Access Compliance Report

Public Rights-of-Way

(Curb Ramps)

Intersection ID: 10019926	Main Street: ARDREY_KELL_RD	Cross Street: N/A	Location: W
ADA ID: 64AE7456DA57	Ramp Type: PerpDiag	Initial Pass/Fail: Pass	Overall Compliance: No
Severity Score: 0.25			
Codes/Mitigation Info/Possible Solution		Field Measurements/Component Compliance

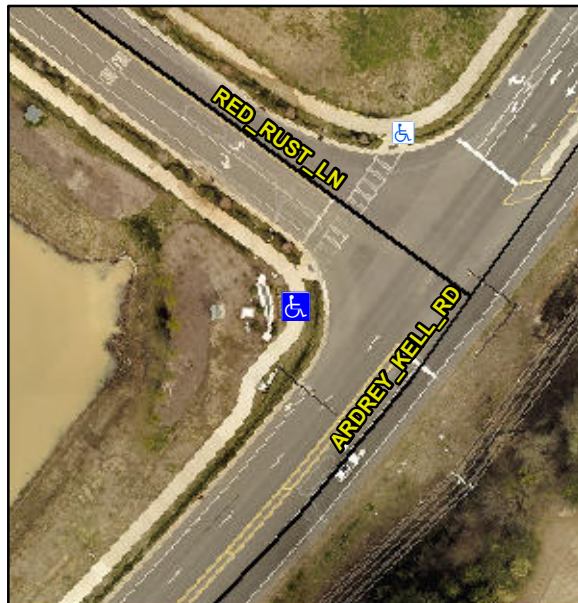
Not Found, R304.5.3, R305.2

Compliance	Description	Data	Compliance	Description	Data
N/A	Ramp Length (in)	95.5	Yes	Ramp Slope (%)	7.4
Yes	Ramp Width (in)	60.0	No	Ramp XSlope (%)	3.5
N/A	Flare Type LT	Sloped	N/A	Flare Type RT	N/A
N/A	Flare Slope LT (%)	9.5	Yes	Flare Slope RT (%)	4.4
N/A	Flare Traversable LT?	Yes	N/A	Flare Traversable RT?	Yes
Yes	Landing Length (in)	94.0	Yes	DWS Provided?	Yes
Yes	Landing Width (in)	58.5	Yes	DWS Contrast?	Yes
Yes	Landing Slope (%)	1.6	Yes	DWS Length (in)	24.0
Yes	Landing X Slope (%)	1.4	Yes	DWS Full Width?	Yes
N/A	Landing Curb? (Y/N)	No	No	DWS Offset (in)	3.0
N/A	Shared Landing?	No			
Yes	Gutter Ponding?	No	Yes	Gutter Slope (%)	1.2
Yes	Gutter Lip Ht (in)	0.0	Yes	Gutter X Slope (%)	1.2
N/A	Painted X Walk1?	No	N/A	Painted X Walk2?	No
	X Walk 1 Direction	To SE		X Walk 2 Direction	To NE
N/A	X Walk 1 Width (in)	N/A	N/A	X Walk 2 Width (in)	N/A
	X Walk 1 Slope (%)	6.8		X Walk 2 Slope (%)	3.4
	X Walk 1 X Slope (%)	3.3		X Walk 2 X Slope (%)	4.5

Remove & Replace Curb Ramp With Two New Directional Ramps or Equivalent.
